Response to Request for Additional Information – ANP-10285P
“U.S. EPR Fuel Assembly Mechanical Design Topical Report” (TAC No. MD7040)

Figure RAI 7-3: Standard Dashpot (left) and MONOBLOC™ (right) Guide Tube Configurations

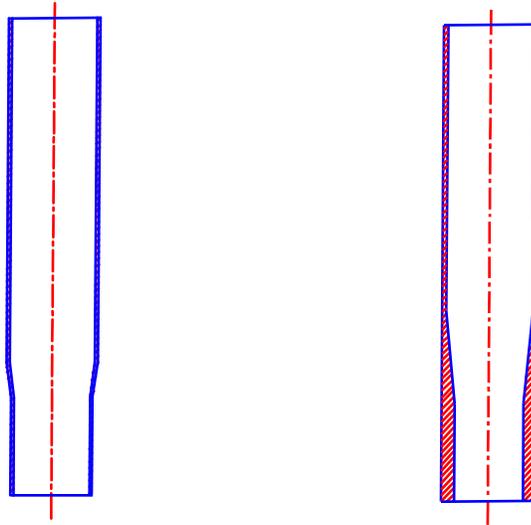
RAI-7. *Regarding Section 3.6, M5TM Alloy Guide Tube, please provide operational experience and test data of the MONOBLOCTM guide tube design. Identify differences between the MONOBLOCTM and the standard dashpot GT design. Is MONOBLOCTM guide tube design approved for use by the NRC?*

The primary difference between the MONOBLOC and the standard dashpot GT designs is the exterior configuration (Figure RAI 7-3). The MONOBLOC design reflects a constant outer diameter (OD) and two inner diameters (ID). The upper-section ID is larger to accommodate rapid RCCA insertion. The ID decreases over a short transition zone to the smaller ID in the lower section of the guide tube creating the dashpot region and resulting in an increased wall thickness. The standard swaged GT design, on the other hand, has a constant wall thickness that is mechanically reduced forming a short conical section creating the dashpot region. TR Table 3-4 presents a dimensional comparison between the U.S. EPR MONOBLOC versus the standard guide tube design.

Per BAW-10227P-A, the use of M5 for structural materials is approved by the NRC. The structural design of the U.S. EPR fuel assembly with the MONOBLOC guide tube design follows NRC approved methodologies; however, no specific geometrical configuration of the MONOBLOC guide tube was explicitly approved by the NRC.
